DESCRIPTION	DATE
DESIGN REVIEW	03.21.2022
1ST REVIEW COMMENTS	04.22.2022

DRAWING TITLE
BUILDING ELEVATIONS - NORTH

A3.201

THE CUBES AT MESA - BLDG A
E PECOS RD & S CRISMON RD, MESA, AZ 85212

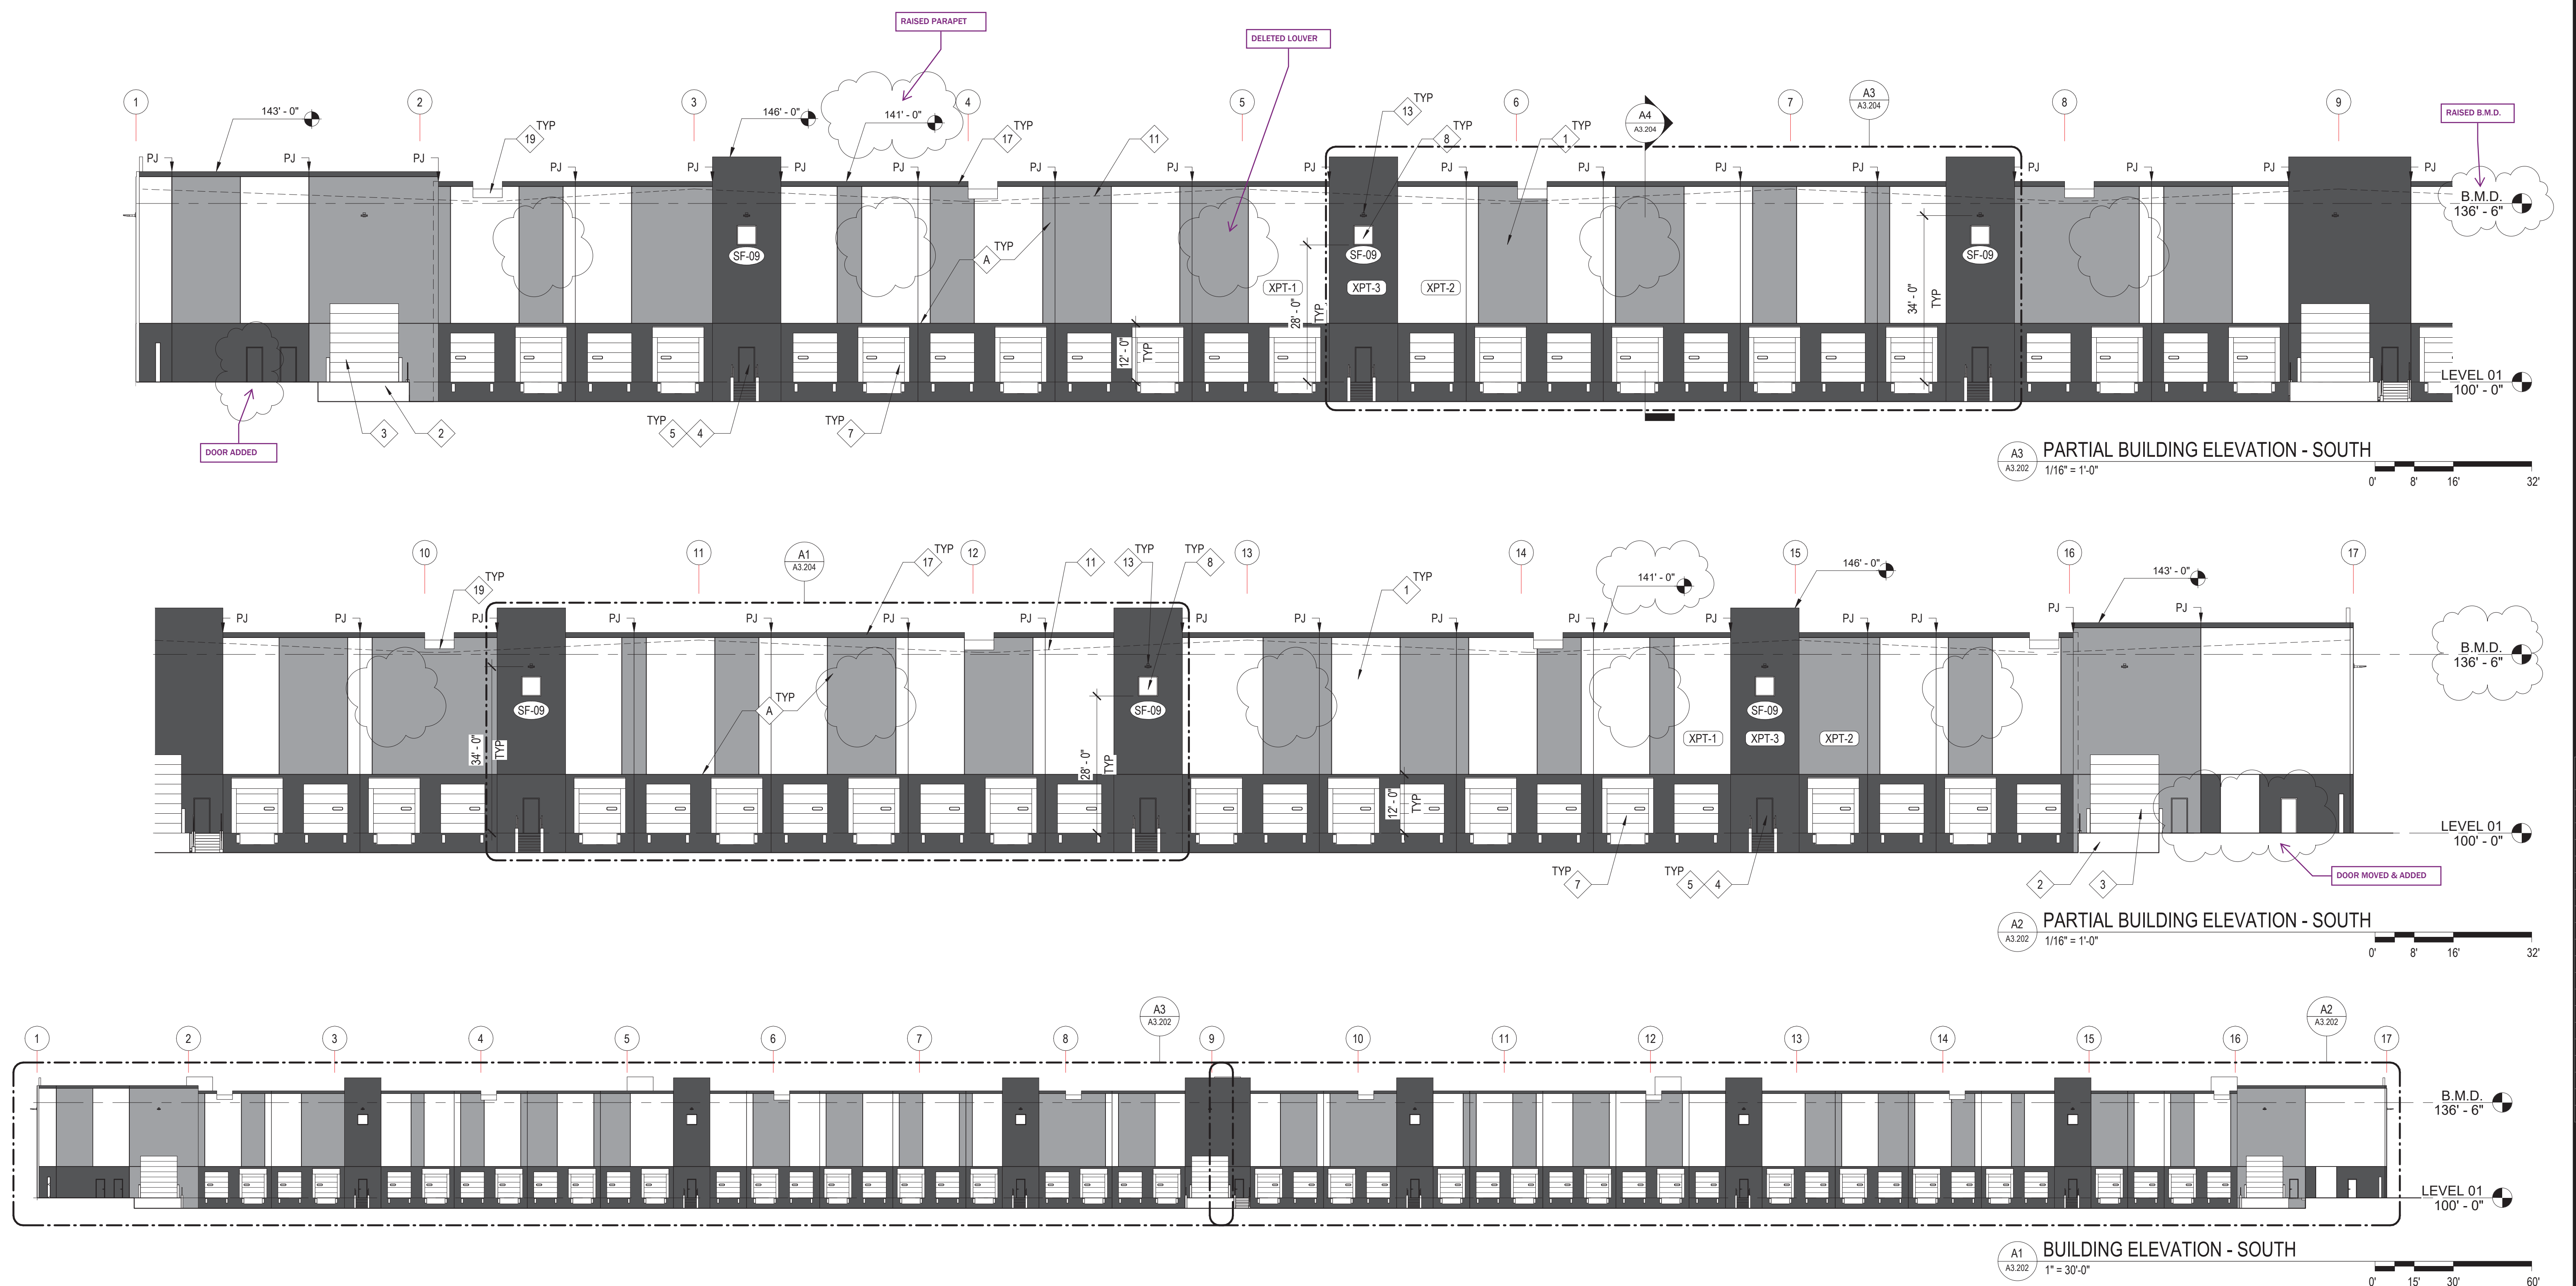
ADDED LEGEND

+A3-02

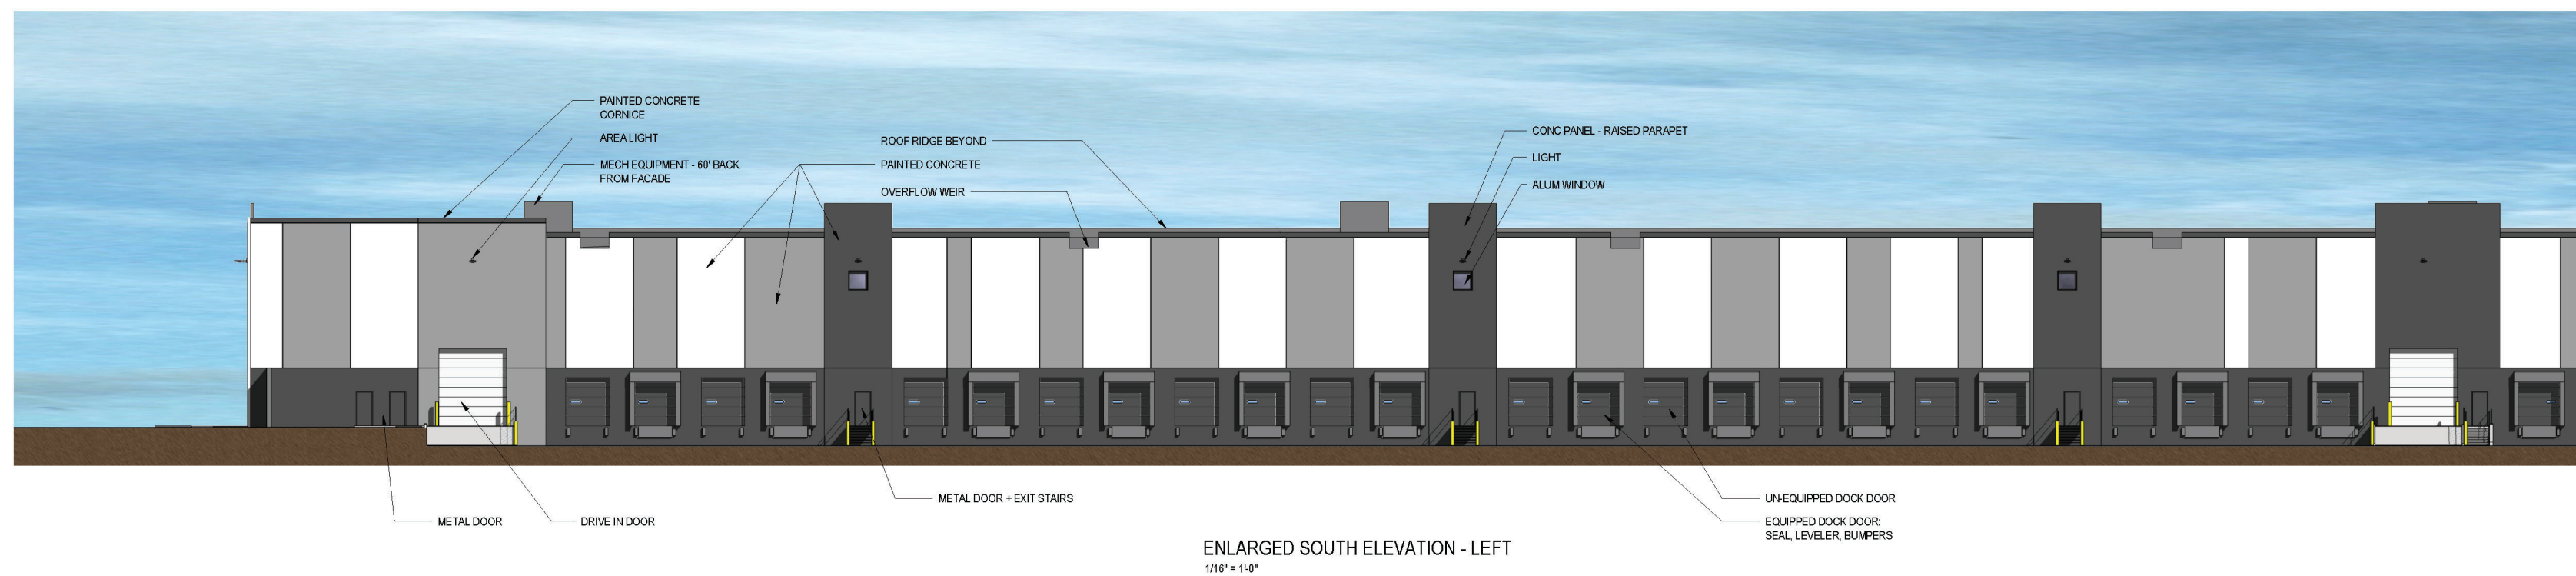
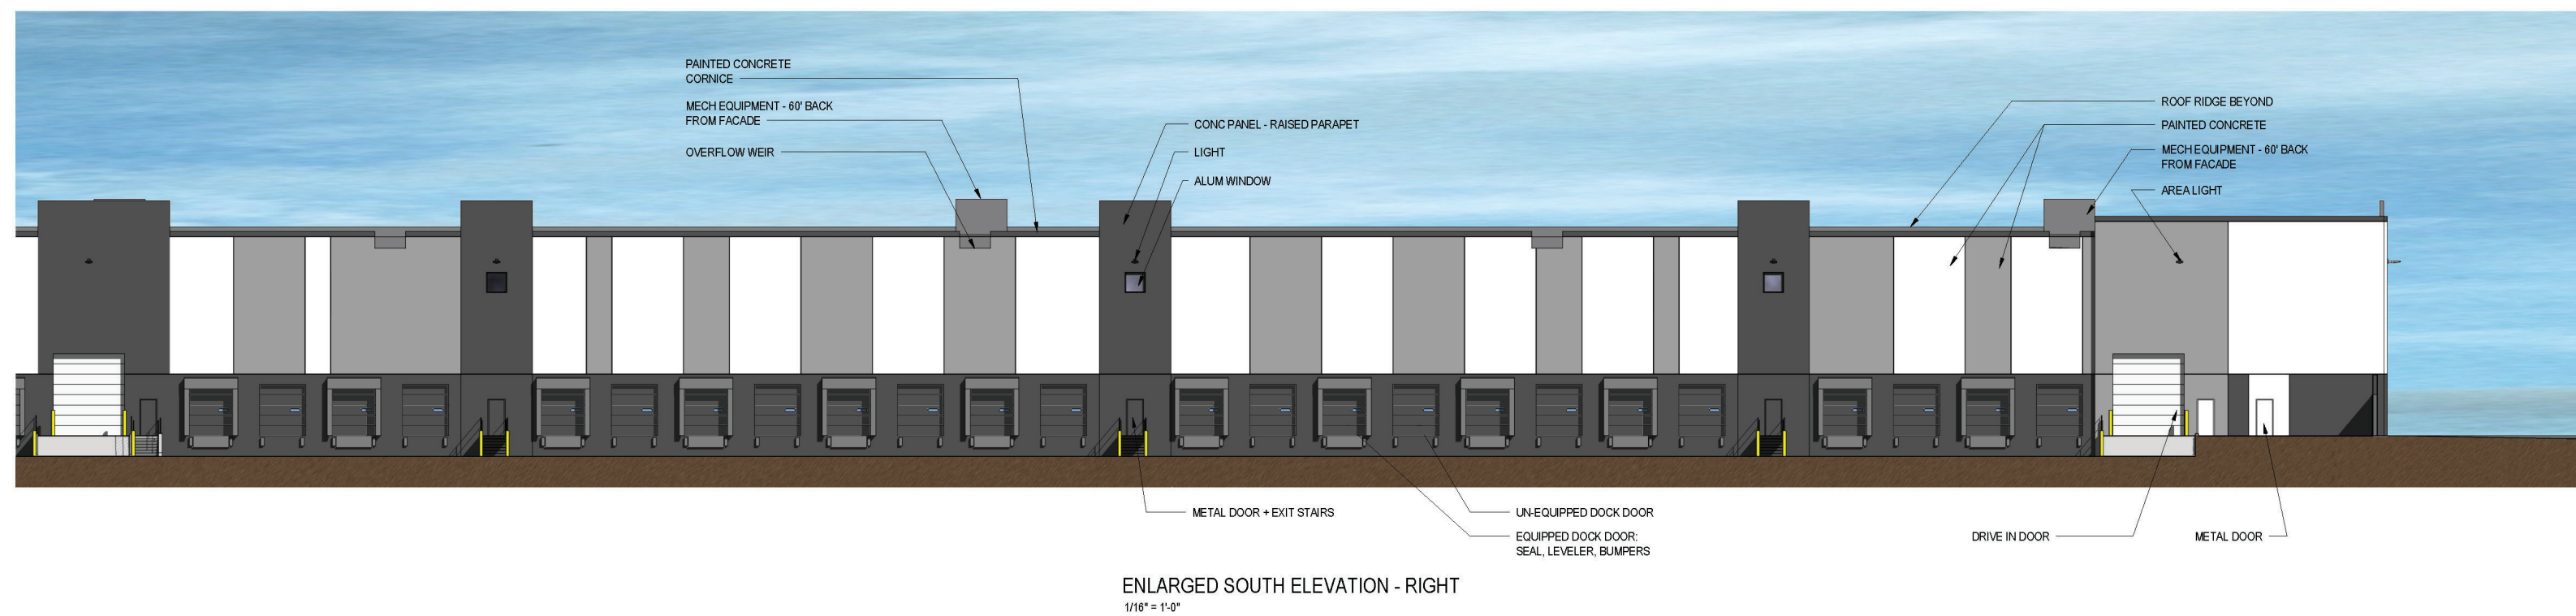
1. Dock Doors color changed to Knights Armor.
2. Ventilation louvers removed on South Elevation.
